CITY OF SHELBYVILLE

PLAN COMMISSION

MEETING DATE: 9/27/2021

Case Number & Name:	PC 2021-14; SR 44 Outlot/Urgent Care; Site Development Plan			
Petitioner's Name:	Civil & Environmental Consultant, Inc.			
Owner's Name:	GWM Real Estate LLC			
Petitioner's Representative:	Rusty Skoog, Civil & Environmental Consultants, Inc.			
Address of Property:	1778 State Road 44, Shelbyville, IN 46176			
Subject Property Zoning Classification:	BH – Business Highway			
Comprehensive Future Land use:	Gateway-Mixed Use			
	North	East	South	West
Surrounding Properties' Zoning Classifications:	Business Highway	Business Highway	Business Highway	Business Highway
Surrounding Properties' Comprehensive Future Land Use	Gateway/ Mixed Use	Gateway/ Mixed Use	Gateway/ Mixed Use	Gateway/ Mixed Use
History:	The site is a new parcel on an outlot subdivided from Rural King.			
Vicinity Map:				
Action Requested:	Site Development Plan approval for a new urgent care facility.

2 FRONT ELEVATION
SCALE: 1/4" = 1'-0"

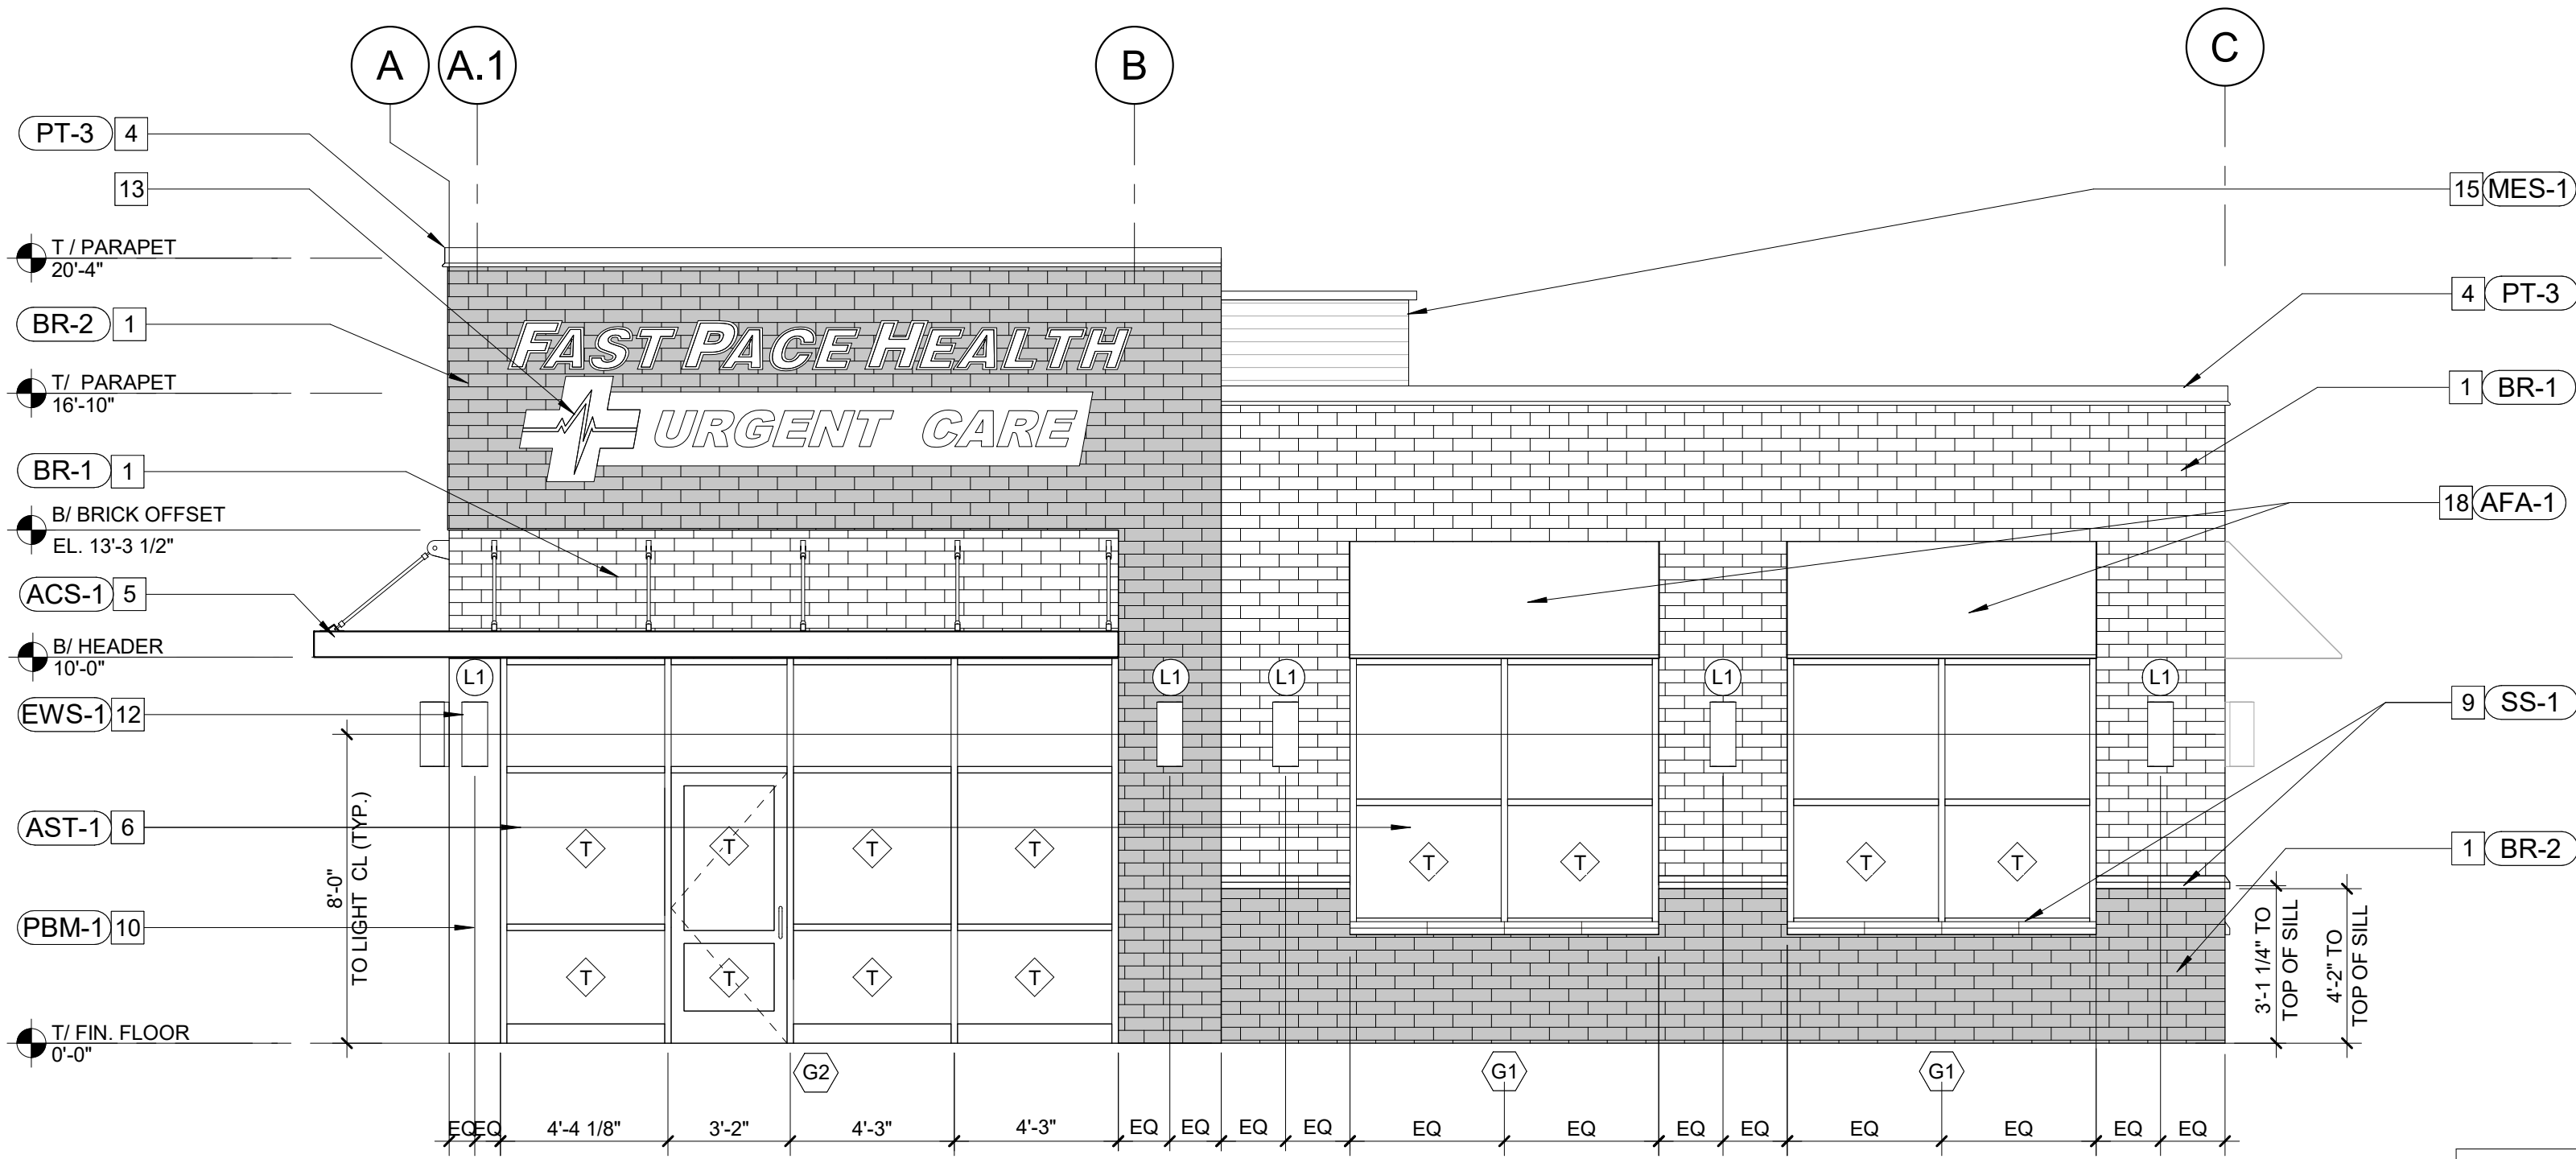
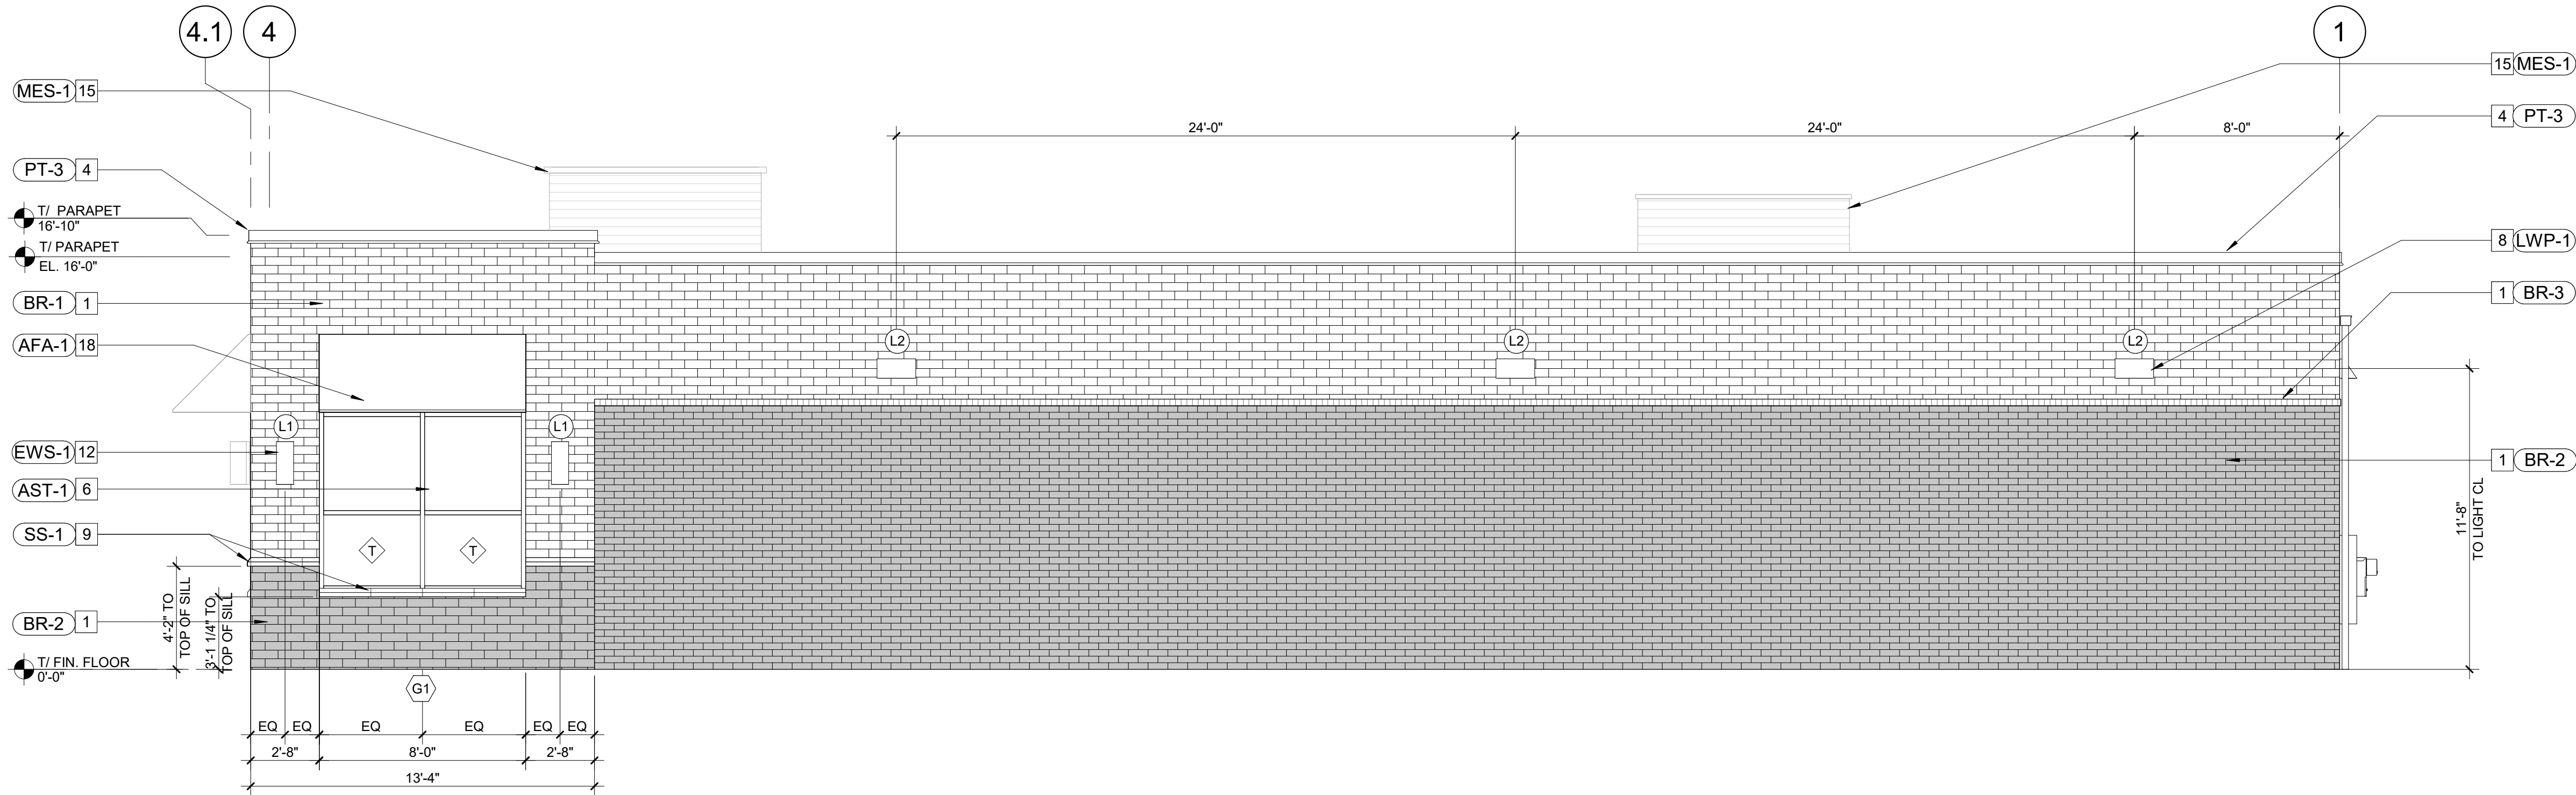
UDO 5.08 Architectural Standards (B)(2):

Roof Design Features: Roofs shall have no less than two (2) of the following features:

- a. Parapets concealing flat roofs and rooftop equipment such as HVAC units from public view. The average height of such parapets shall not exceed fifteen percent (15%) of the height of the supporting wall. Such parapets shall feature three-dimensional cornice

treatment.

Note: The parapet does not appear to be a three-dimensional cornice treatment.

1. Elevations are resubmitted and approved by the Planning Staff.
2. Plan for Rural King Parking reconfiguration submitted and approved by the Planning Staff.

1 REAR ELEVATION
SCALE: 1/4" = 1'-0"

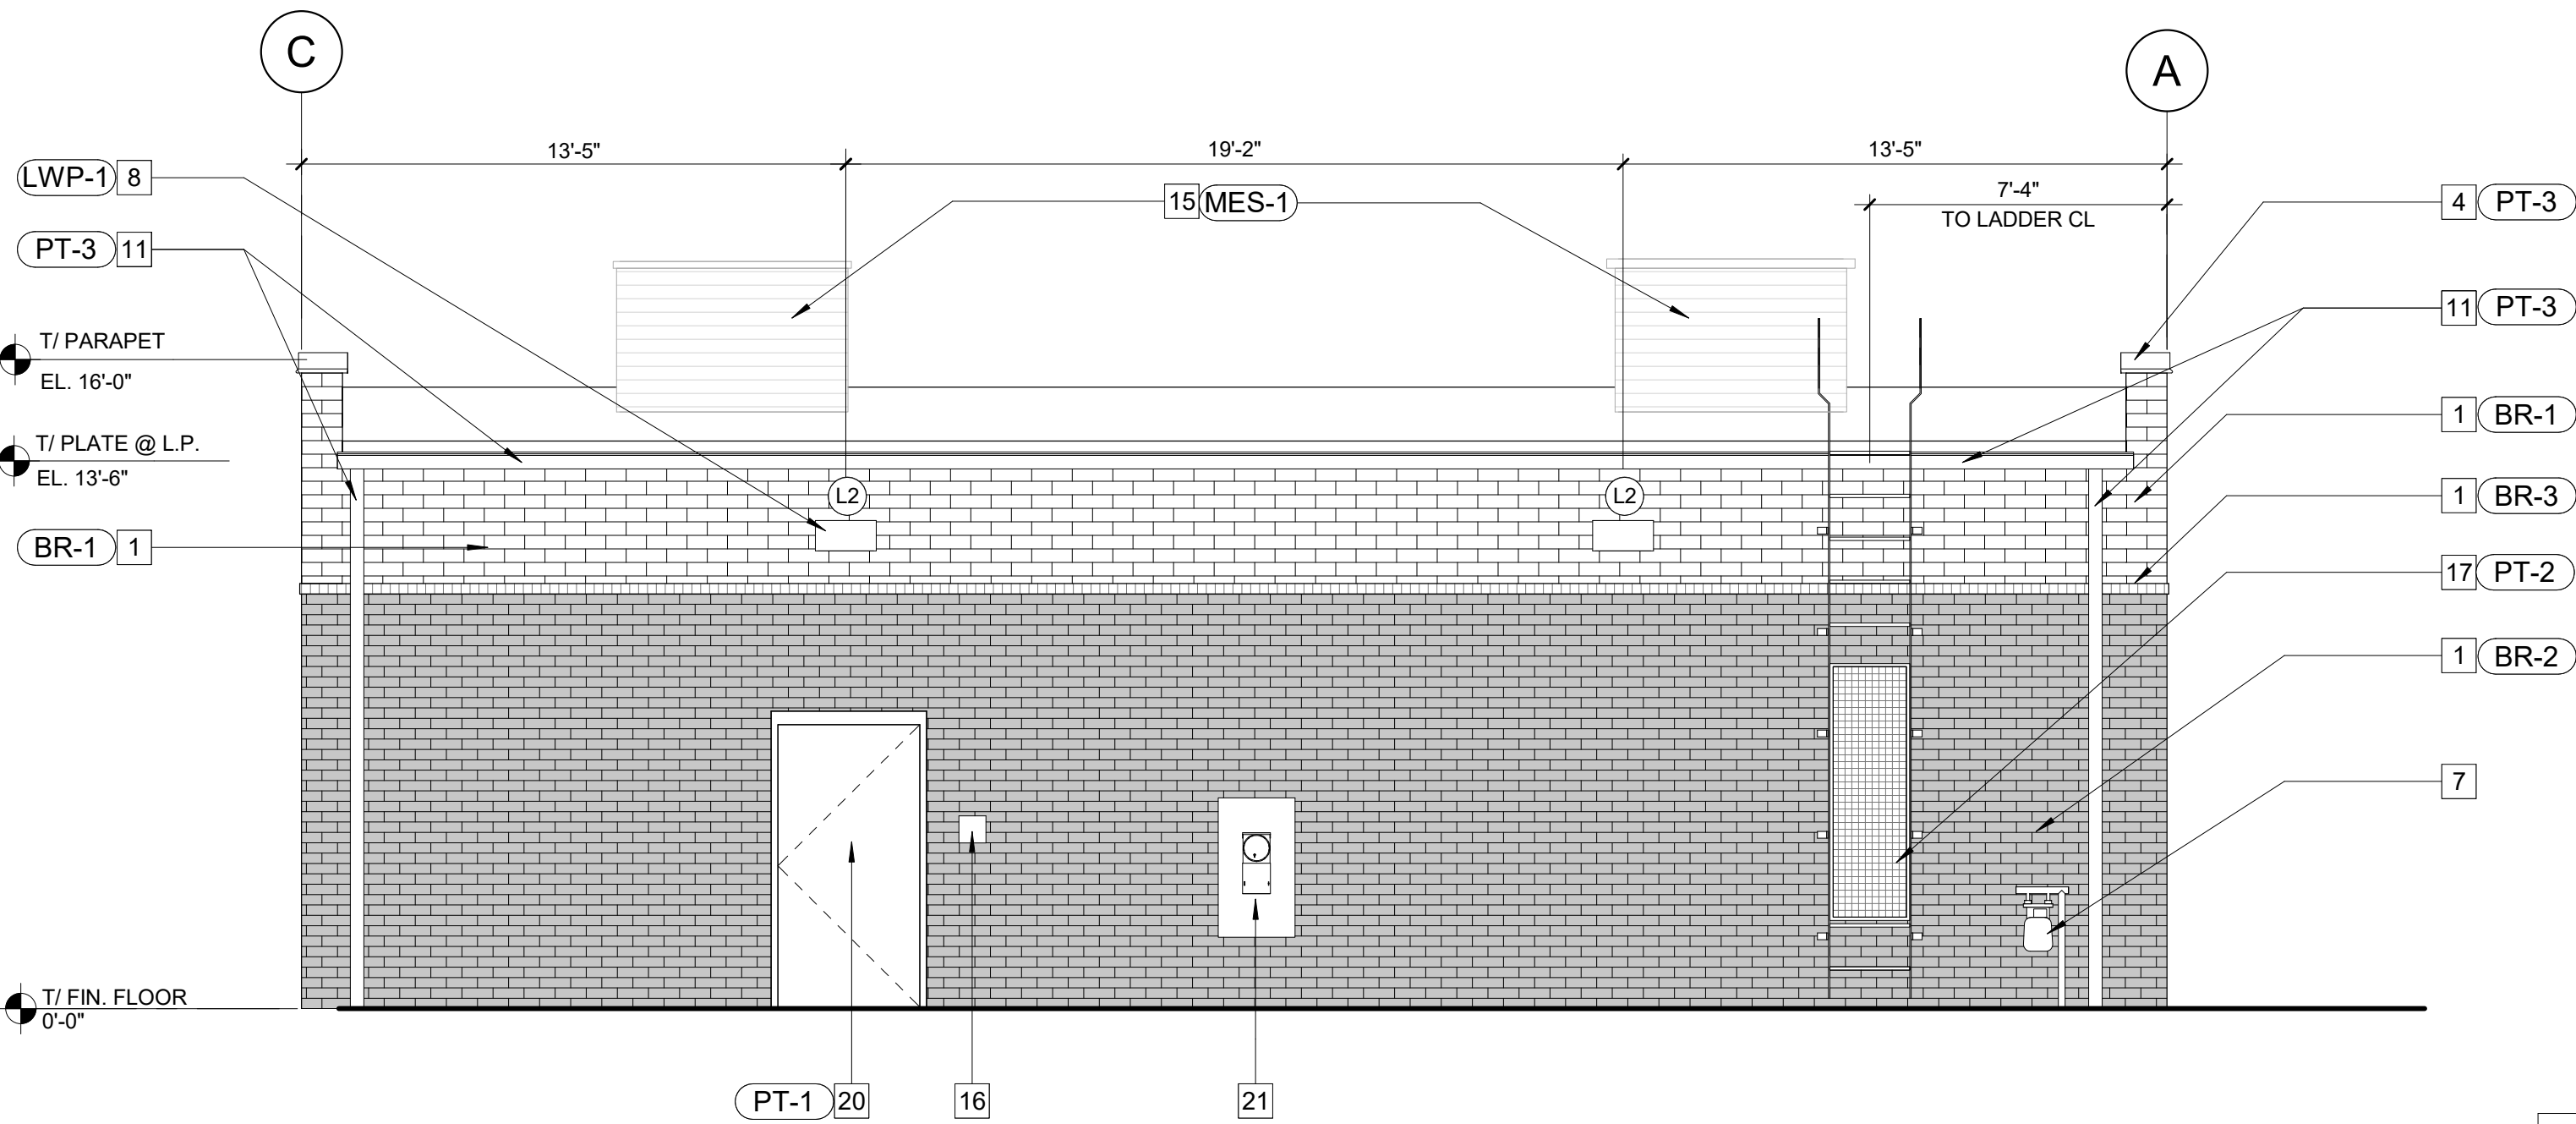
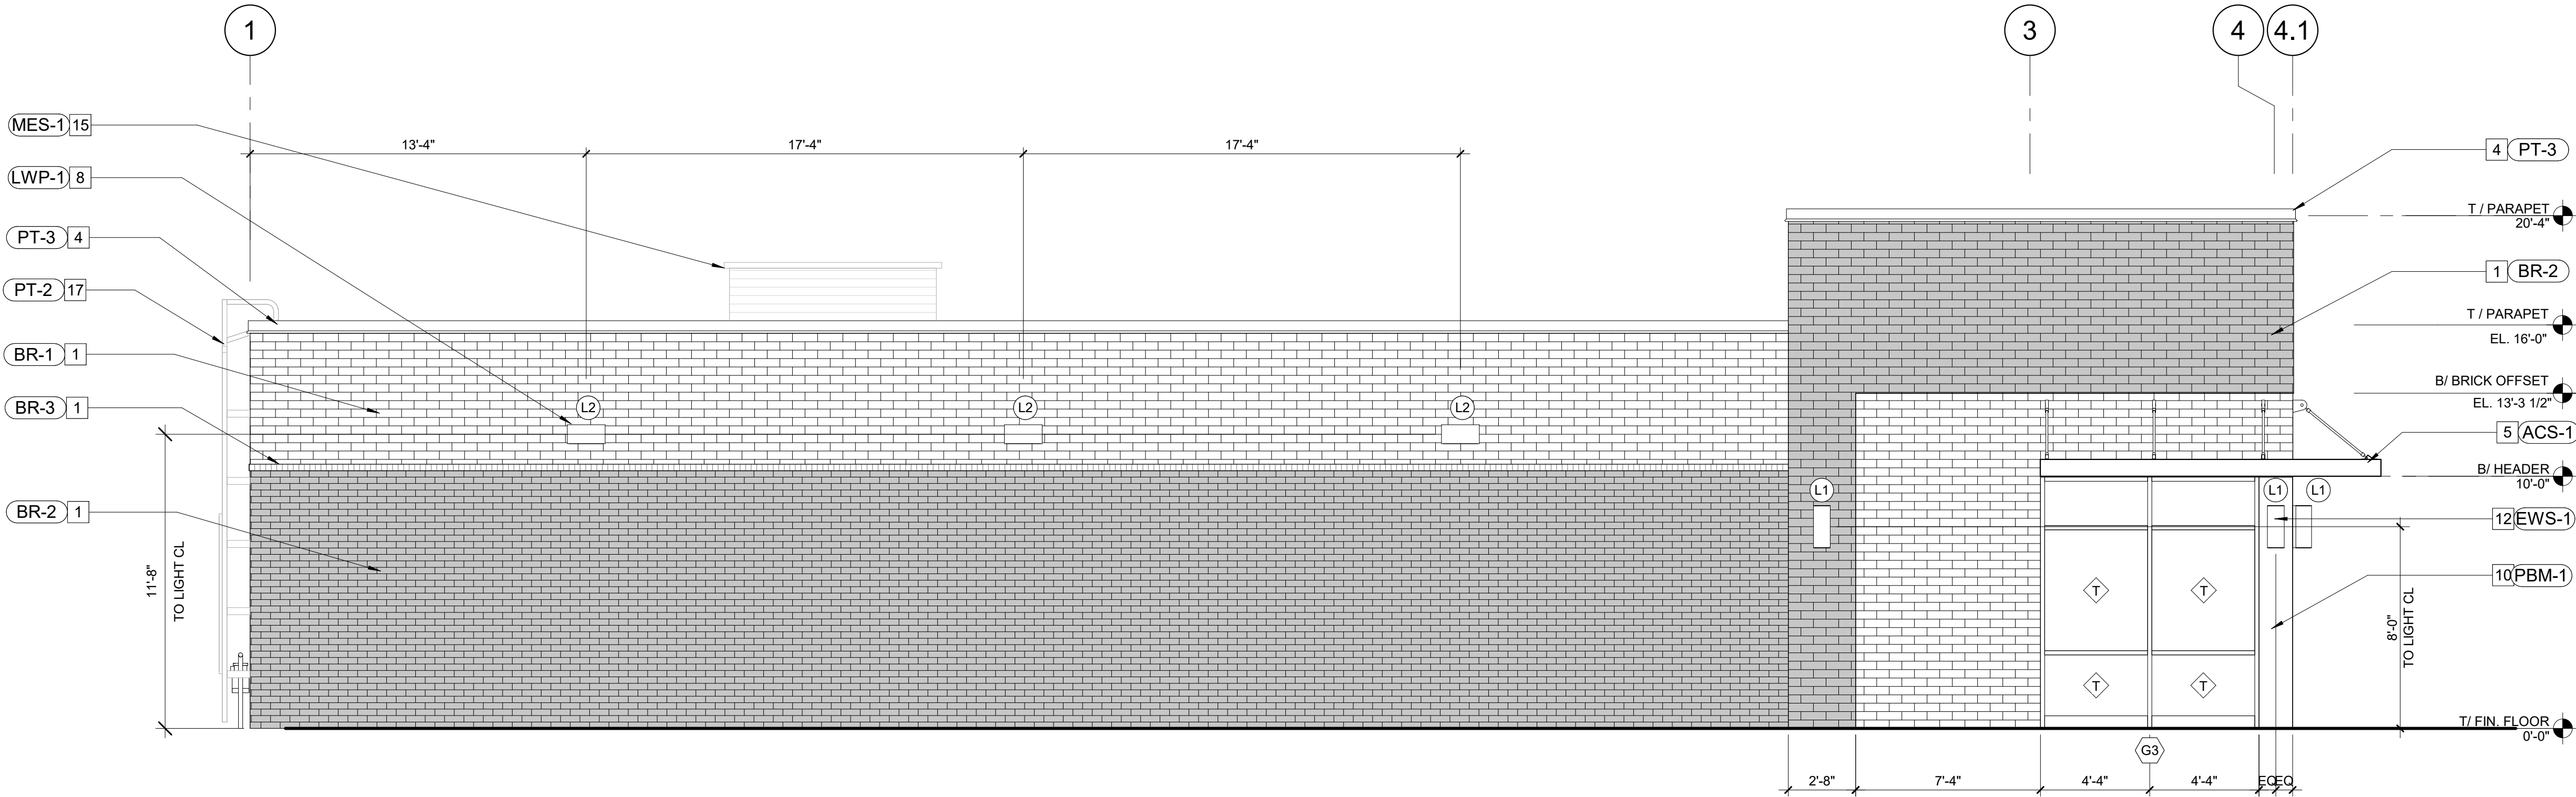
UDO 5.08 Architectural Standards (A)(5):

Ground Floor Facades: Ground floor facades that face public streets shall have arcades, display windows, entry areas, awnings, and/or other such features, along no less than sixty percent (60%) of their horizontal length.

Note: The rear and side elevations are not meeting this requirement. The design needs to incorporate faux windows or other features into the elevations.
